Subject: Bullawah Wind Farm (SSD-50505215)

ATTACHMENT A – BCS Assessment Summary for Bullawah Wind Farm Environmental Impact Statement (SSD-50505215)

ATTACHMENT B – BCS detailed advice for Bullawah Wind Farm EIS

Figure 1: Screenshot of Figure 8.5.1 from the BDAR showing areas of Plains-wanderer important habitat mapping circled in red that are likely to be fragmented and isolated by construction/upgrade of tracks and cable trenches.

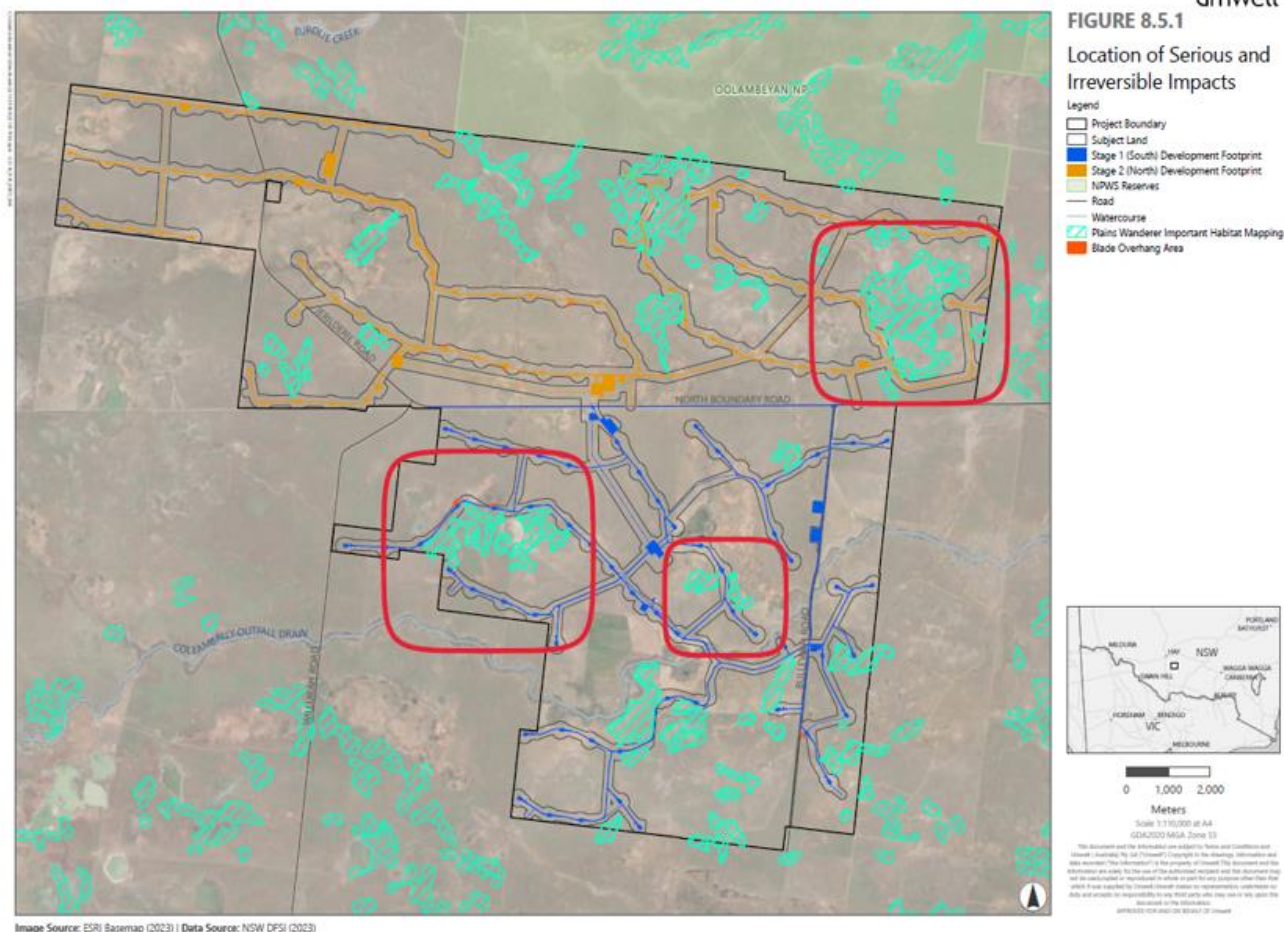
For example, Figure 1 below replicates BDAR Figure 8.5.1 and shows the location of habitat for SAI entities. BCS have identified (red squares) the areas of mapped Plains-wanderer important habitat that will be surrounded by new or upgraded roads, turbines, turbine pads and cable infrastructure. In line with the requirements set out in section 6.1.3b of the BAM, the BDAR needs to describe the importance of connectivity between these areas of habitat with surrounding mapped habitat (including within Oolambeyan National Park and BCT Plains-wanderer Conservation Agreements) for maintaining movement that is crucial to the species life cycle. The assessment should include the potential impact of these areas being sterilised due to lack of connectivity.

The Plains-wanderer SAI assessment has not considered potential fragmentation impacts "as no important habitat would be removed". Because indirect impacts to Plains-wanderer have not been addressed in section 8.2 of the BDAR, the consent authority cannot rely on the SAI assessment outcomes in section 8.4 of the BDAR to make an informed decision about potential SAI to this species.
